**Waterford 3
Generic Letter 2004-02
Response to RAIs**

March 8, 2010

Discuss Waterford 3's responses to NRC Request for Additional Information (RAIs) for GL 2004-02

RAI #16

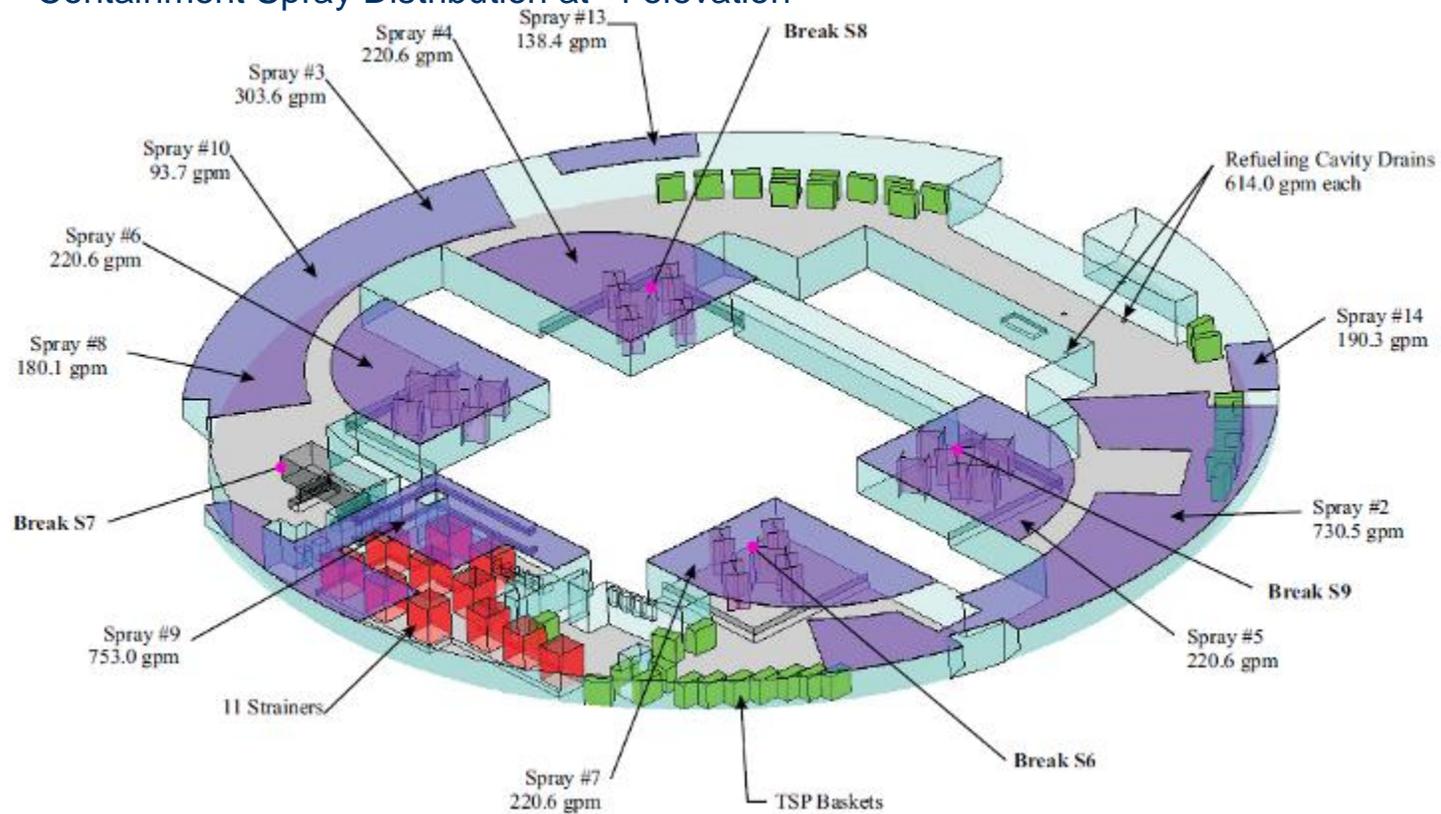
- Please identify the distance from the strainer at which debris was added to the test flume. Please justify the conservatism or prototypically of this distance based on the transport analysis results for blowdown, wash down, and pool-fill transport. Please specifically discuss consideration of the debris addition in the head loss testing for the fraction of paint chips and other containment debris that would have the potential to wash down onto the strainers from upper containment elevations, and would thus not have to climb over the suction plenum to reach the strainer surface.

- WF3 will be performing new head loss testing in 2010.
- New head loss testing will be performed as set forth in the NRC March 28, 2008 head loss testing guidance and consistent with previously NRC reviewed Alion protocols.
- All but one break is at a significant distance from the sump.
- For the S7 break, a concrete wall separates blowdown from the sump
- Wash down will only come from Containment Spray in a very limited area over the sump. See attached sketch of +46 elevation of RCB
- Transport is based on all debris starting on the containment floor

RAI #36*

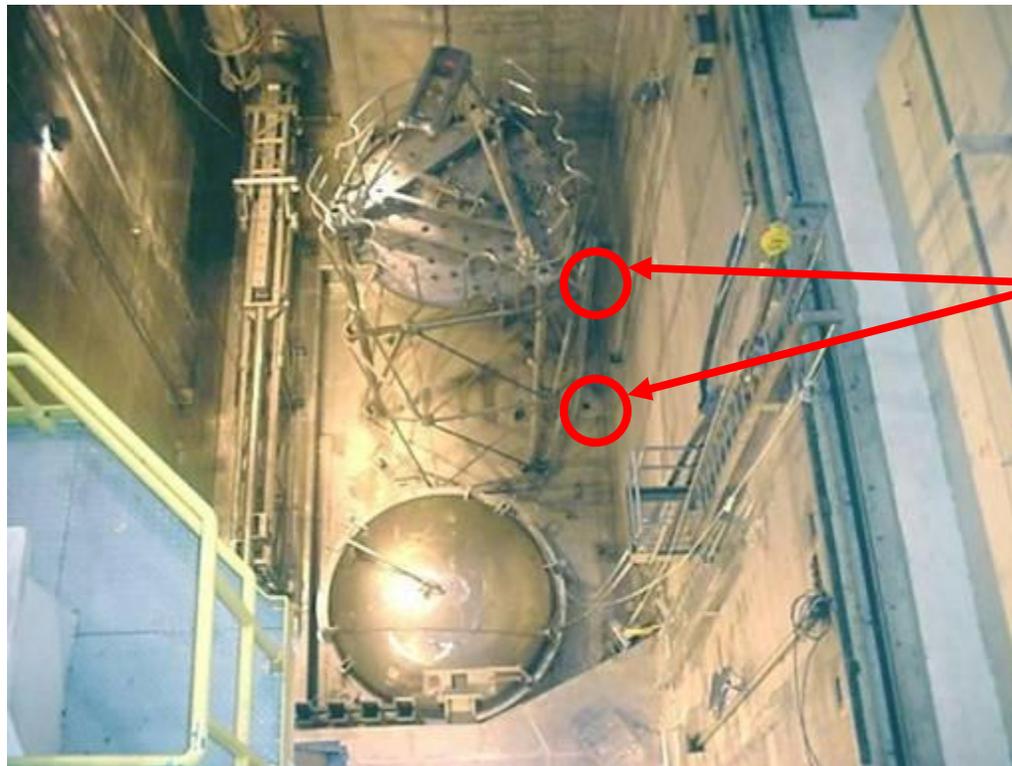
- The sump level calculation assumes that no holdup occurs in the refueling canal. Audit Open Item 16 requested that the licensee provide information justifying that the drain lines would not block and provide a holdup volume. The evaluation provided in the supplemental response dated October 23, 2008, was based on judgment and lacked technical basis or any information beyond that provided during the audit. Holdup in the refueling canal will affect sump level, and therefore, net positive suction head margin. Please provide additional information that justifies that the refueling canal drains cannot become fully or partially blocked so that no hold up will occur. Waterford 3 has hundreds of cubic feet of fiber, as well as miscellaneous debris and other materials.

- It is not clear that the upper guide structure lift rig and an access ladder (diver stairs) are sufficient to keep larger debris out of the drains for the refueling canal. The supplemental response does not address why large pieces of debris cannot be blown into the upper containment. If such debris ends up in the refueling cavity, it is not clear that temporary floatation, transport by surface currents over the drain, and subsequent soaking with water, can be ruled out. If drain blockage can be ruled out, then please identify whether any water buildup is necessary to create sufficient driving head for flow to occur through the drain for a clean condition. Alternately, if drain blockage cannot be ruled out, then please evaluate the potential holdup in the refueling canal and its effect on pool water level.

- 5 of the 7 breaks analyzed for GSI-191 are below the 14 ft elevation and are inside the containment D-rings. The top of the D-rings are at elevation 62.25.
- The breaks in the Pressurizer cubicle (S7) and at the reactor (S2) are shielded by physical structures (walls, grating, cavity ring seal) from sending debris in to the upper areas of containment or into the reactor cavity.
- The 5 breaks in the D-rings would have to project debris larger than 6 inches (drain size) through an obstruction filled D-ring (see attached sketch and pictures) and then over the D-ring wall.
- The debris would then be required to fall on top of the drain, as debris 6" or larger would not transport in the cavity.
- Sufficient flow can be achieved through the drains without requiring any measurable level in the pool.
